Re: Turkey Point Nuclear Plant, Units 3 and 4  
Docket Nos. 50-250 and 50-251  
Renewed Facility Operating Licenses DRR-31 and DPR-41

License Amendment Request No. LAR-229  
Application for Technical Specification Change Regarding Risk-Informed Justifications  
for the Relocation of Specific Surveillance Frequency Requirements to a Licensee  
Controlled Program

#### **License Amendment Request No. LAR-229**

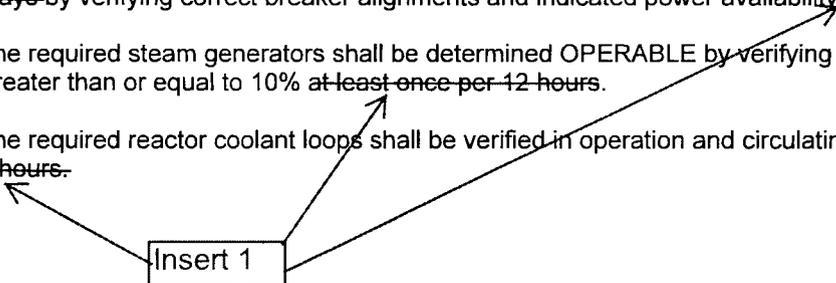
4.4.1.2.2 The required steam generators shall be determined OPERABLE by verifying secondary side water level to be greater than or equal to 10% ~~at least once per 12 hours~~.

4.4.1.2.3 The required reactor coolant loops shall be verified in operation and circulating reactor coolant ~~at least once per 12 hours~~.

Insert 1

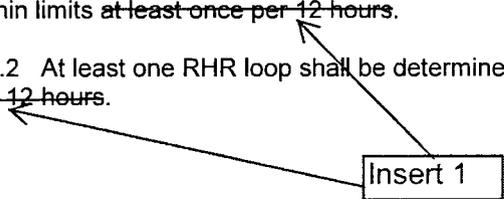
4.4.1.4.1.1 The secondary side water level of at least two steam generators when required shall be determined to be within limits ~~at least once per 12 hours~~.

4.4.1.4.1.2 At least one RHR loop shall be determined to be in operation and circulating reactor coolant ~~at least once per 12 hours~~.

Insert 1

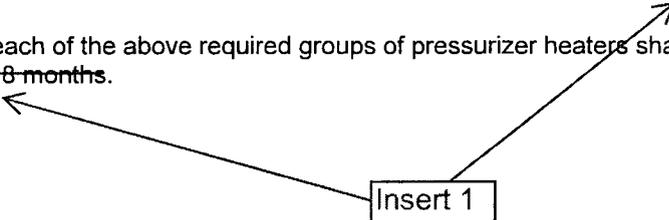
4.4.3.1 The pressurizer water volume shall be determined to be within its limit ~~at least once per 12 hours.~~

4.4.3.2 The capacity of each of the above required groups of pressurizer heaters shall be verified to be at least 125 kw ~~at least once per 18 months.~~

Insert 1

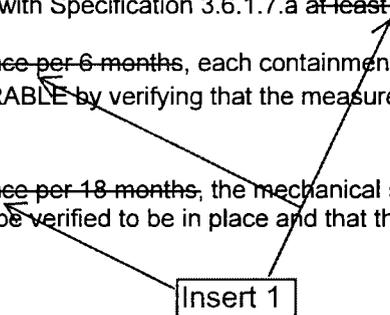
4.6.1.7.2 ~~At least once per 6 months~~, each containment purge supply and exhaust isolation valve shall be demonstrated OPERABLE by verifying that the measured leakage rate is less than or equal to  $0.05 L_a$  when pressurized to  $P_a$ .

4.6.1.7.3 ~~At least once per 18 months~~, the mechanical stop on each containment purge supply and exhaust isolation valve shall be verified to be in place and that the valves will open no more than 33 or 30 degrees, respectively.

Insert 1

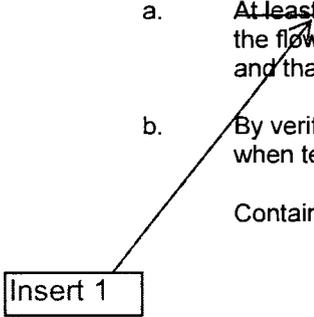
- a. ~~At least once per 31 days~~ by verifying that each valve (manual, power-operated, or automatic) in the flow path that is not locked, sealed, or otherwise secured in position, is in its correct position and that power is available to flow path components that require power for operation;
- b. By verifying that on recirculation flow, each pump develops the indicated differential pressure, when tested pursuant to Specification 4.0.5:

Insert 1

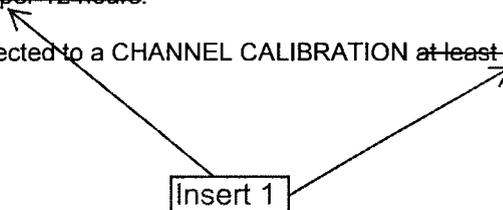
4.9.8.1.1 At least one RHR loop shall be verified in operation and circulating reactor coolant at a flow rate of greater than or equal to 3000 gpm ~~at least once per 12 hours.~~

4.9.8.1.2 The RHR flow indicator shall be subjected to a CHANNEL CALIBRATION ~~at least once per 18 months.~~

Insert 1
